E5070B-01

S E R V I C E N O T E

E5070B ENA Series Network Analyzer, 300 kHz to 3 GHz

Handler I/O Port Malfunction Due to TTL-Low Level Threshold Voltage Anomaly

Figure 1. Threshold voltage anomaly

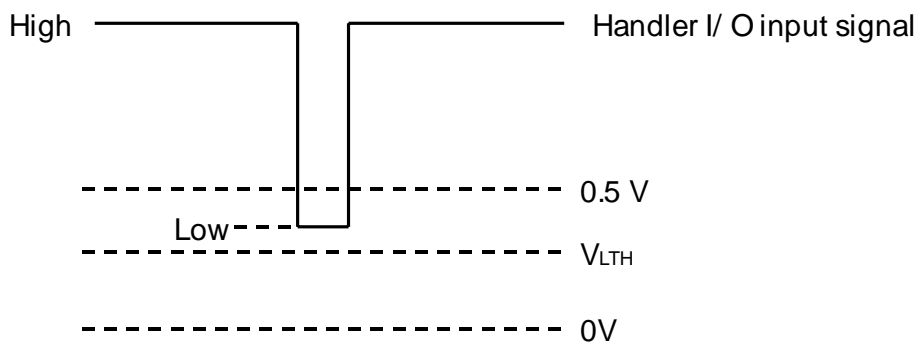
The 24-bit handler I/O of the E5070B units with the specified serial numbers may not function normally. Due to the possible threshold-voltage anomaly of TTL input circuit at either of the I/O pins 2, 18 and 22 through 29, the handler I/O port may ignore the “Low” state of control input signals. When the threshold voltage for TTL-Low level is too low (lower than 0.5 V), it is possible that control input signal does not cross the threshold voltage (V_{LTH}) though the “Low” level of the signal is within the recommended voltage range (0 V to 0.5 V). As a result, a handler interface error occurs. See Figure 1.

When the threshold voltage of the handler I/O (either of the I/O pins) is too low, replace the A23 Handler I/O board with new one (P/N E5070-61006).
